## ADDENDUM

Project Name: Health Life Safety Work: Electrical Systems Replacement at: Quincy Junior High School

Addendum Number: 1

Issued: 4/9/2020

**A101**

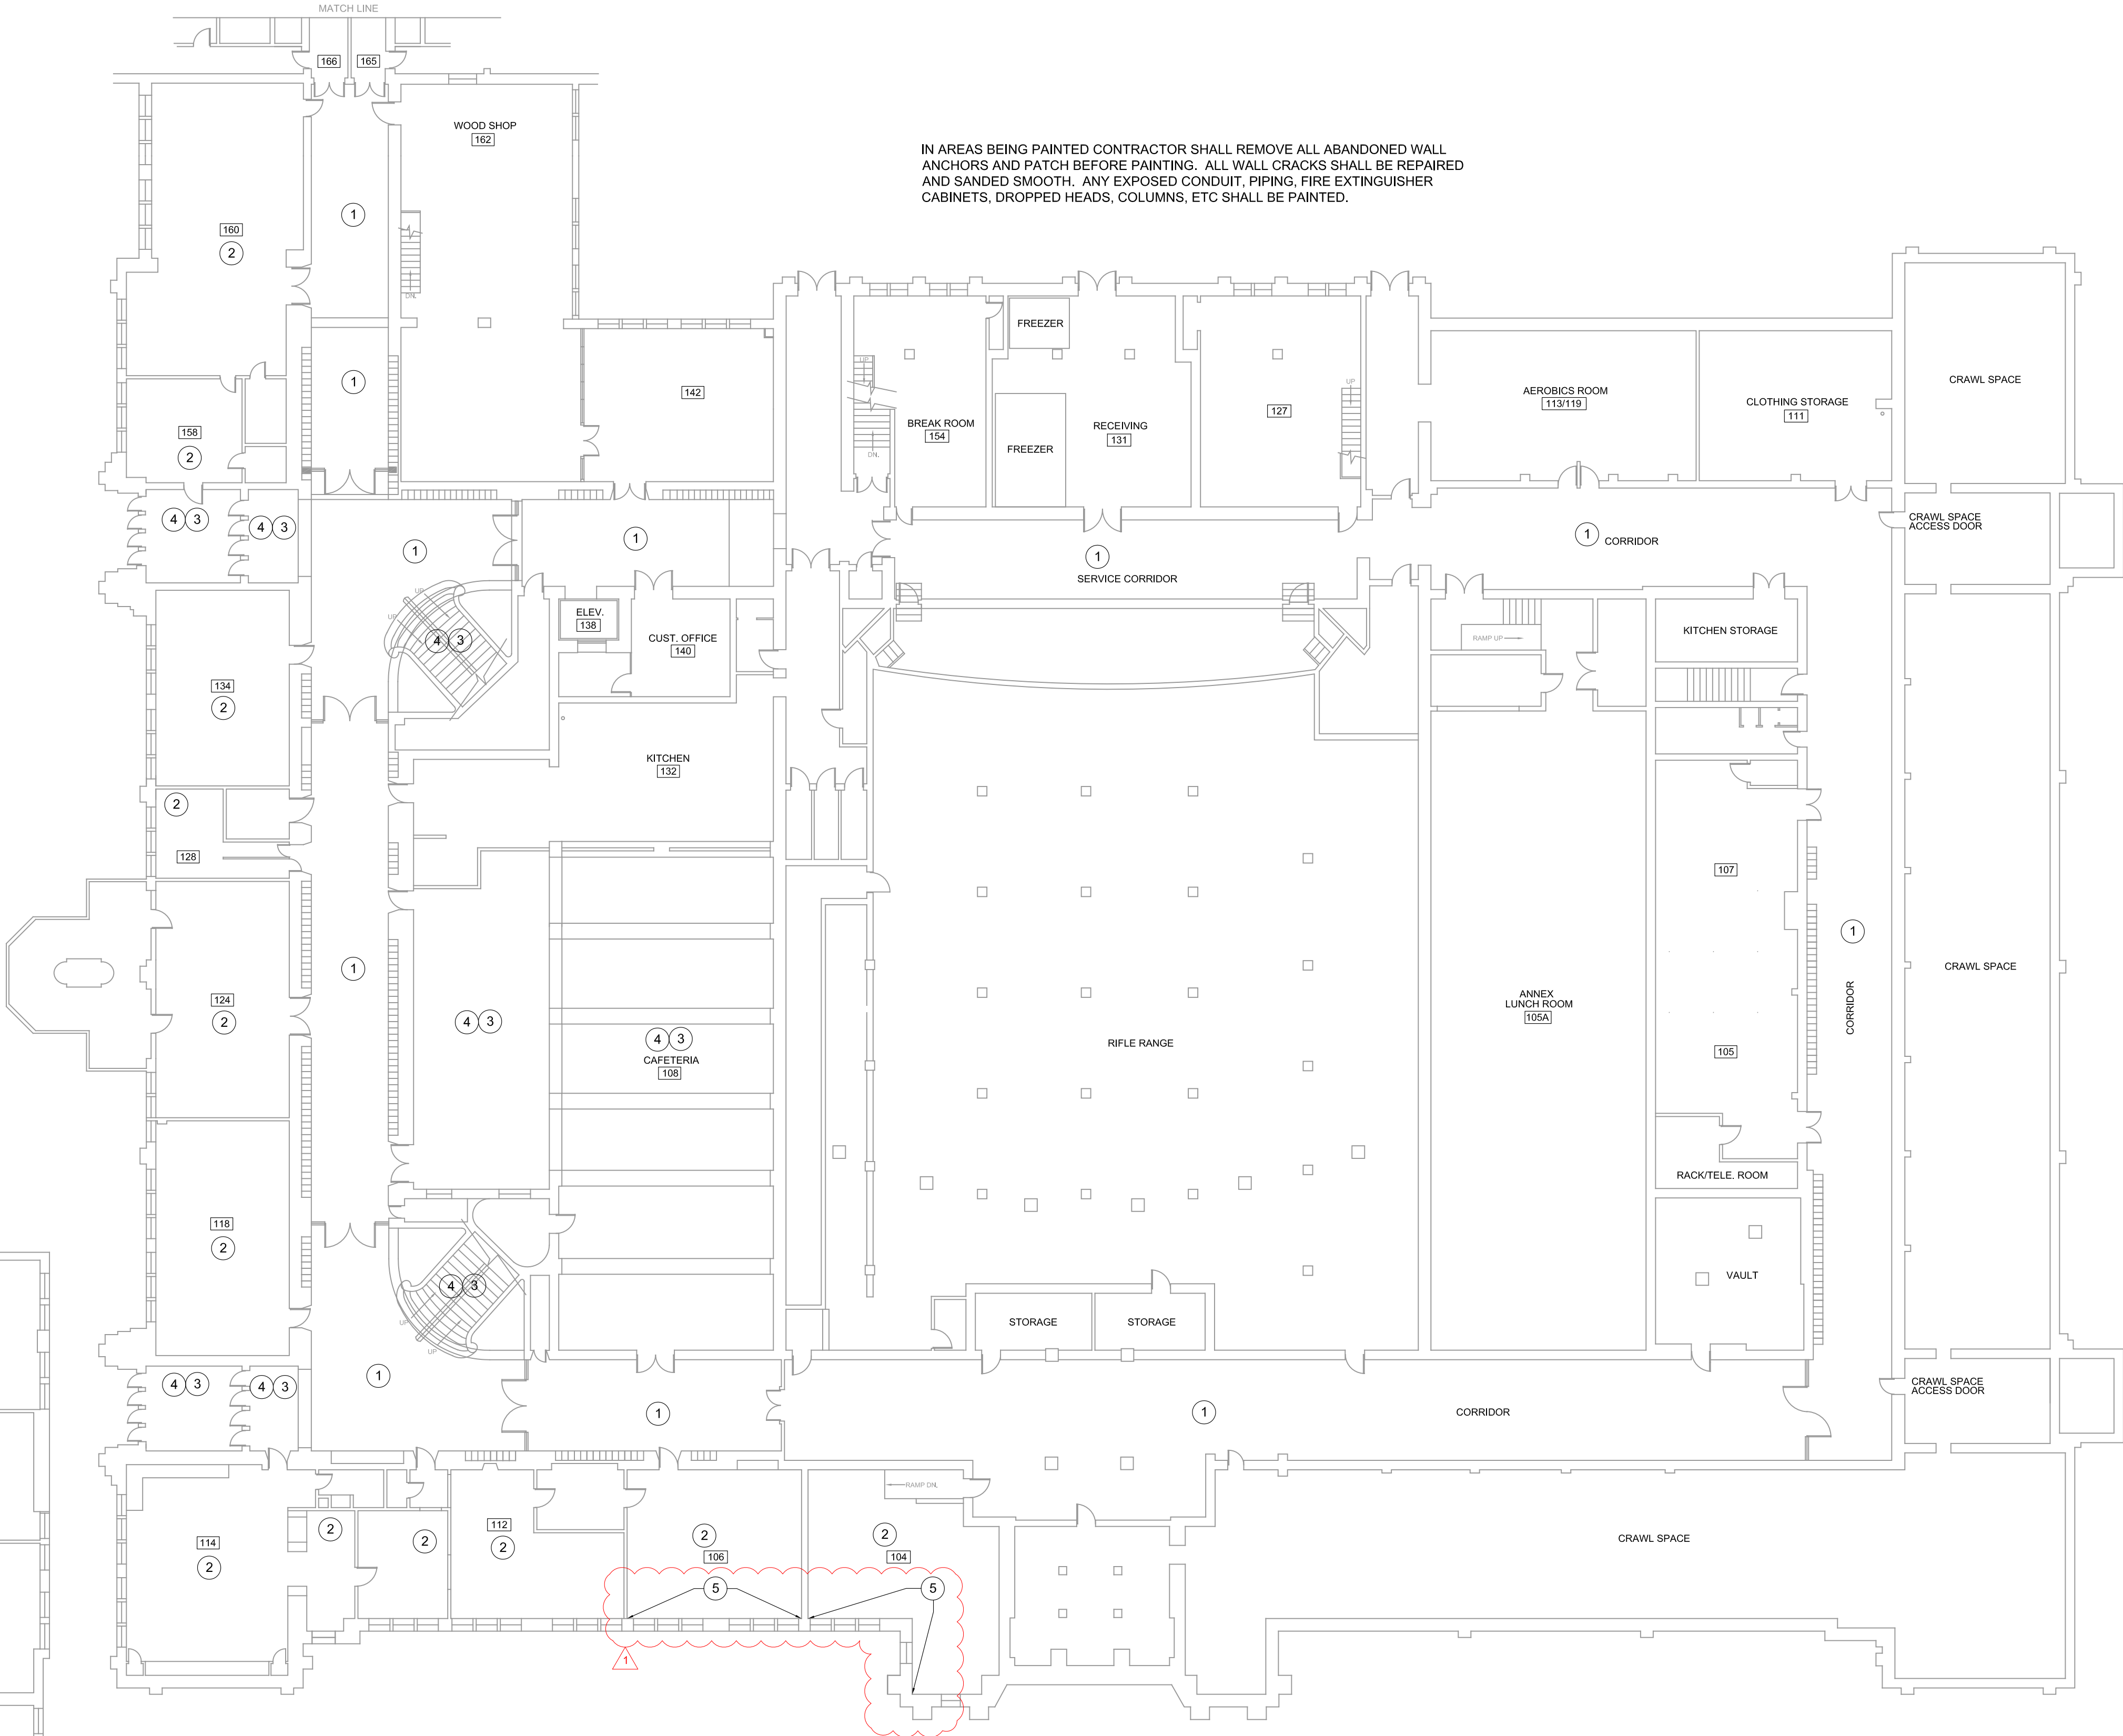
A101, A201, A301, A401	Add	See revised drawings with additional areas of plaster repair identified beyond the normal scope.
A201	Add	See revised drawing where Notes #4 and #5 were added to Auditorium restrooms.
E101, E201, E301, E401, E501	Add	See revised drawings and notes regarding CAT6 cabling drops and additional phone locations. Existing Data Hub/Rack locations are also shown.
E102, E202	Add	See revised drawings adding Note #19. Ceiling grid and light fixtures in Annex were added to the scope (Dwg. E102). Auditorium restroom drawings and Note #19 were added to the scope (Dwg. E202).
E202	Revise	See revised drawing - Light fixture notes in Room 221 were changes to Note #1.
E402	Add	See revised drawing showing location of new Main Lighting Control Hub. Locations of other equipment will be coordinated with the district.
